Committee-of-the-Whole Agenda

**South Slope Wastewater Treatment Plant
Discharge Permit Renewal Update
May 2015**

CHANGE ORDER NO. 2

PROJECT: North Slope WWTP Improvements
OWNER: City of Moline
CONTRACT: 1-2014
CONTRACTOR: Williams Brother Construction, Inc.

Structure 10
 Base Slab/Micropile Plan

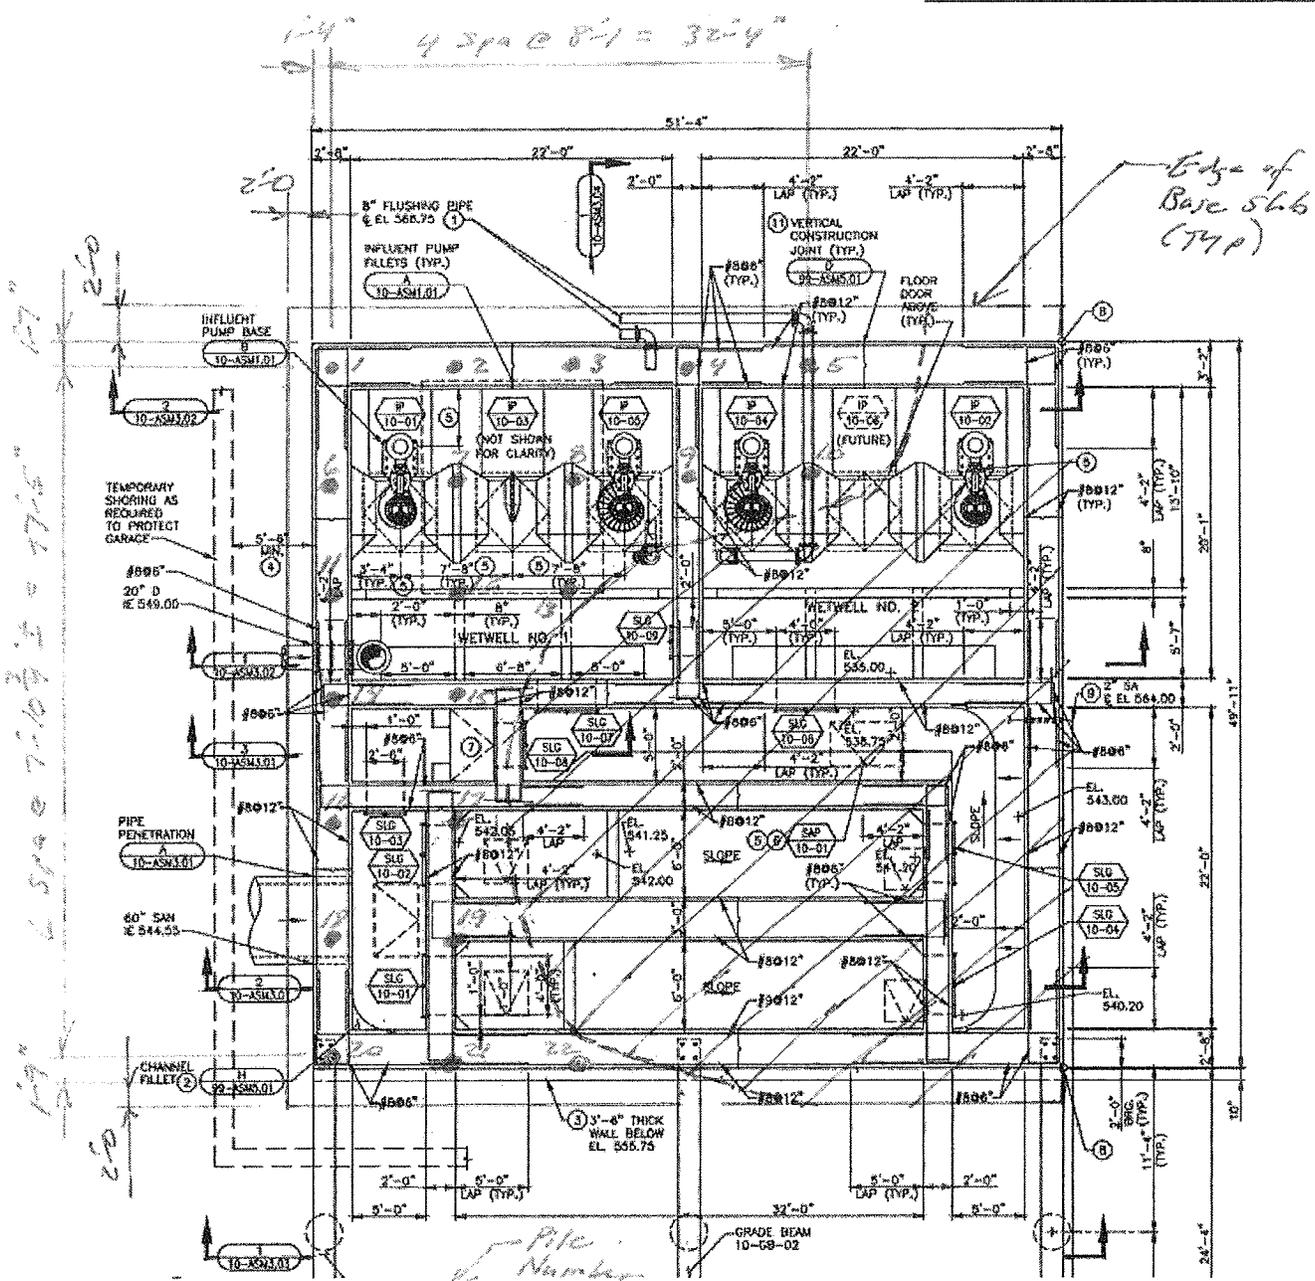
Required bond length
 $200,000 \text{ lbs} = 75 \frac{\text{lb}}{\text{in}^2} (13.74 \frac{\text{in}^2}{\text{in}}) (L)$
 $L = 194 \text{ in} = \underline{16.16 \text{ FT}}$

= New Micropile with 100-Ton service load capacity (Typ of 32)

Struct 70

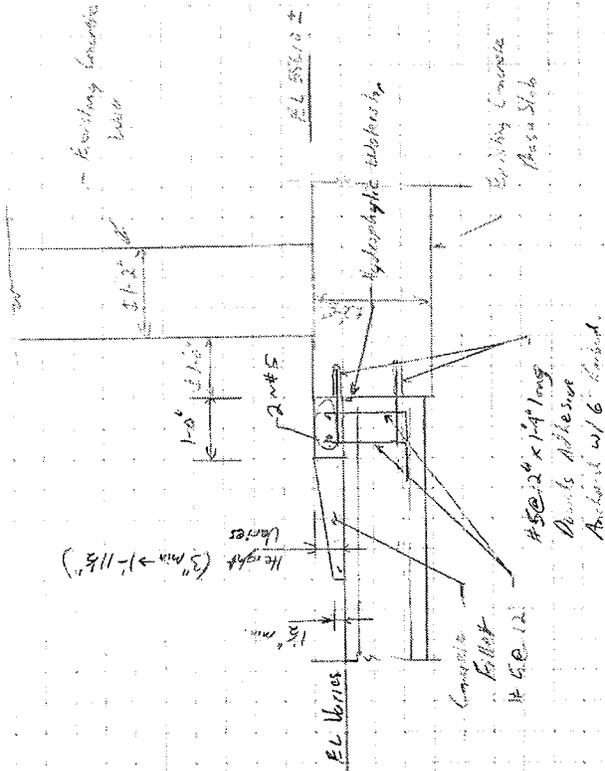
001-01 Clarifications are provided for connection of the base slab between the new and existing sludge storage tanks and the slope/fillets in new Sludge Storage Tanks No. 3 and No. 4. See attached new sections 1 and 2 and revised sections for details.

Section 2
New Section

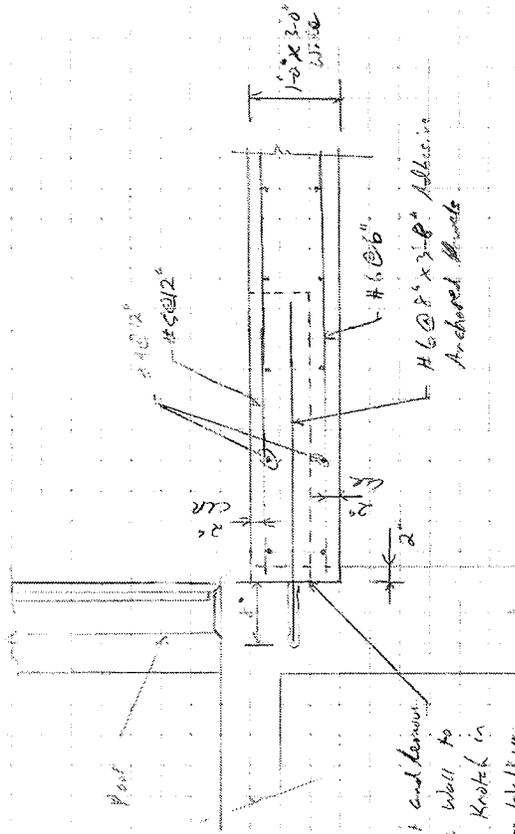
Sawcut and remove
concrete wall to
provide notch in
wall for wall ties.
Lap ties. Roughen
existing surface for
1/2" Adhesive.

JOB NO. 9772-002
 PROJECT MGR. PAUL W. STRAND
 STRAND ASSOCIATES' SHEET 108
 70-ASMS.03

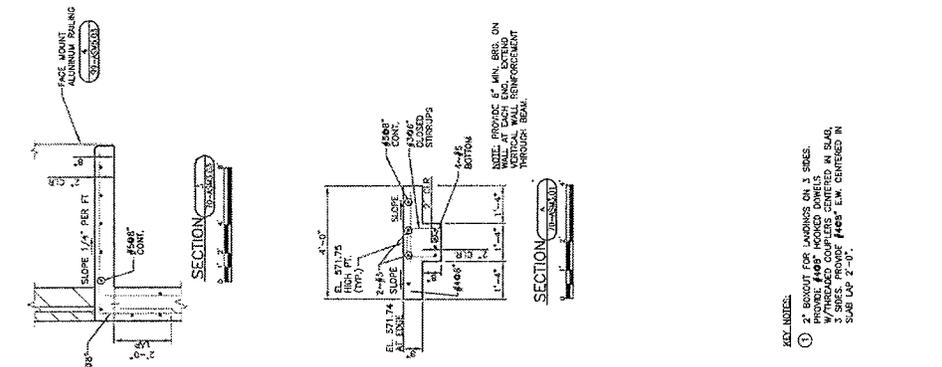
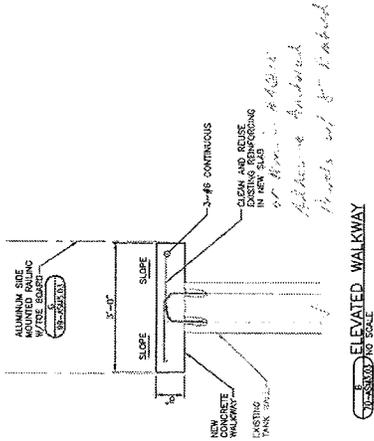
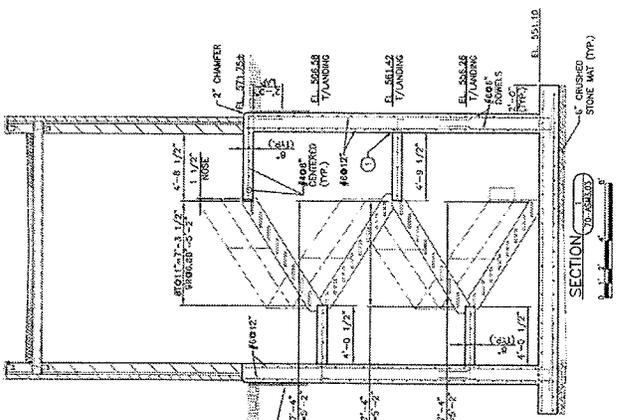
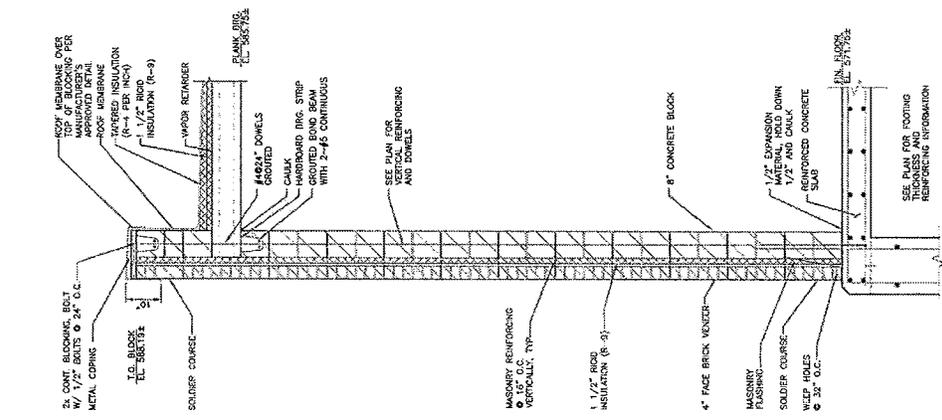
001-04 Clarifications provided to detail B for replaced concrete walkways for sludge storage tanks No. 1 and 2.

Handwritten note:
 Clean and reuse existing reinforcing steel bars
 at bottom of slab
 1/2\"/>
